BEFORE THE
UNITED STATES NUCLEAR REGULATORY COMMISSION

AMENDMENT TO
MAY 23, 1980 and AUGUST 1, 1980
APPLICATION FOR AMENDMENT
OF
FACILITY OPERATING LICENSES
DPR-44 & DPR-56

In the Matter of :
PHILADELPHIA ELECTRIC COMPANY : Docket Nos. 50-277
50-278

AMENDMENT TO
MAY 23, 1980 and AUGUST 1, 1980
APPLICATION FOR AMENDMENT
OF
FACILITY OPERATING LICENSES
DPR-44 & DPR-56

MANAGEMENT ORGANIZATION CHART
PHILADELPHIA ELECTRIC COMPANY

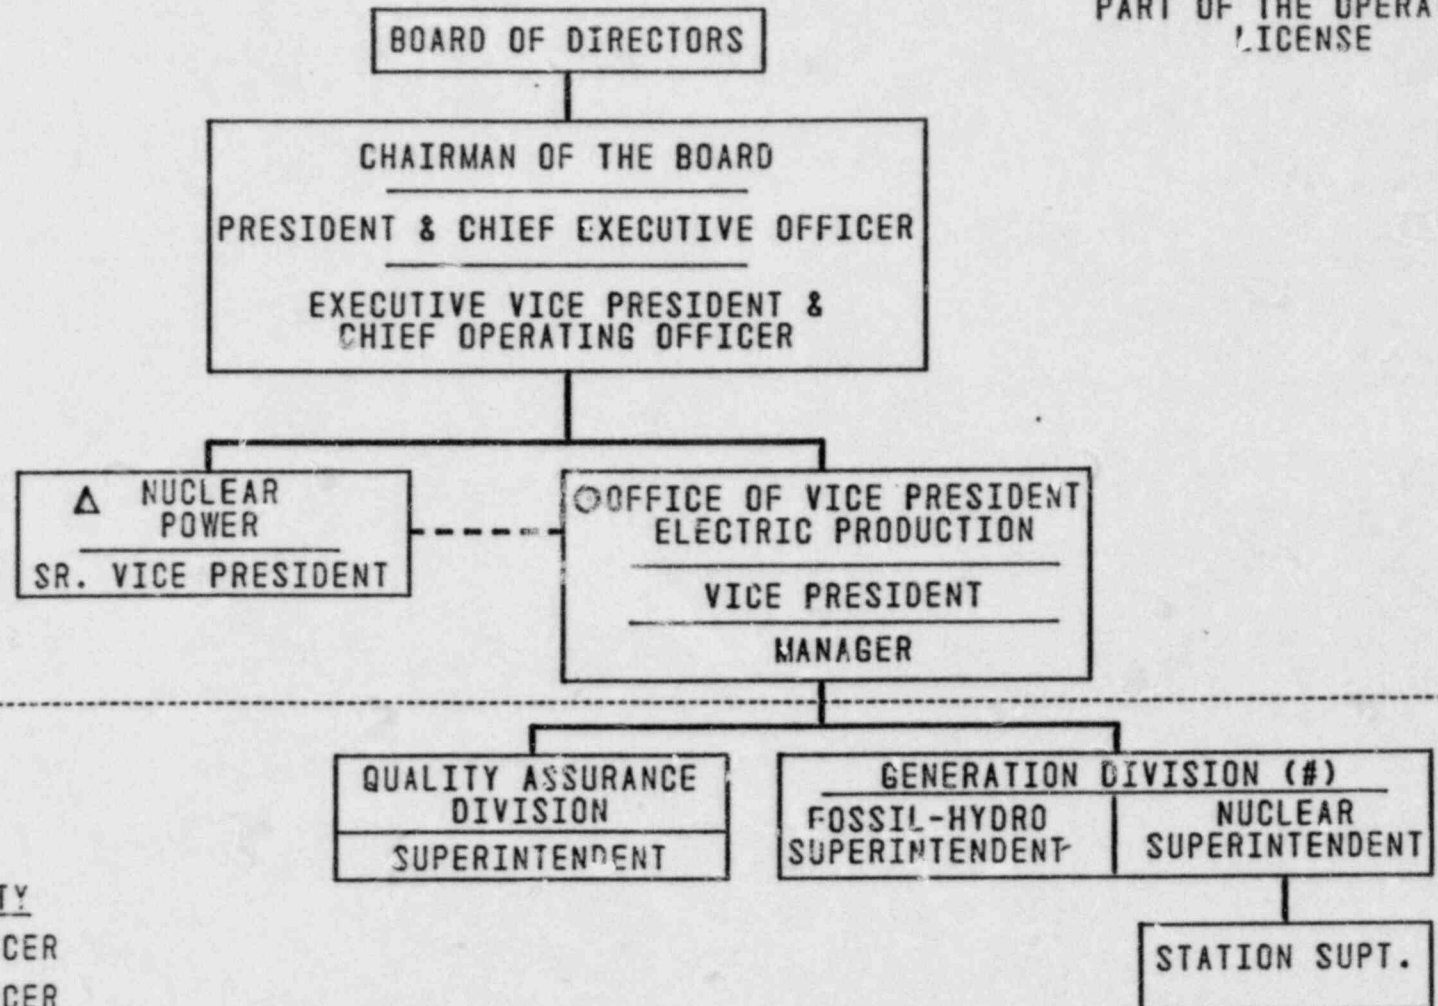
- a) deleting from the Application the proposed change to page 243 of Appendix A to the Operating Licenses and references thereto;
- b) deleting from the application proposed Figure 6.2-1 of Appendix A to the Operating Licenses and substituting therefor the proposed revised Figure 6.2-1 which is attached hereto and incorporated herein by reference; and
- c) deleting from the Application proposed Figure 7.1-1 of Appendix B to the Operating Licenses and substituting therefor the proposed revised Figure 7.1-1 which is attached hereto and incorporated herein by reference.
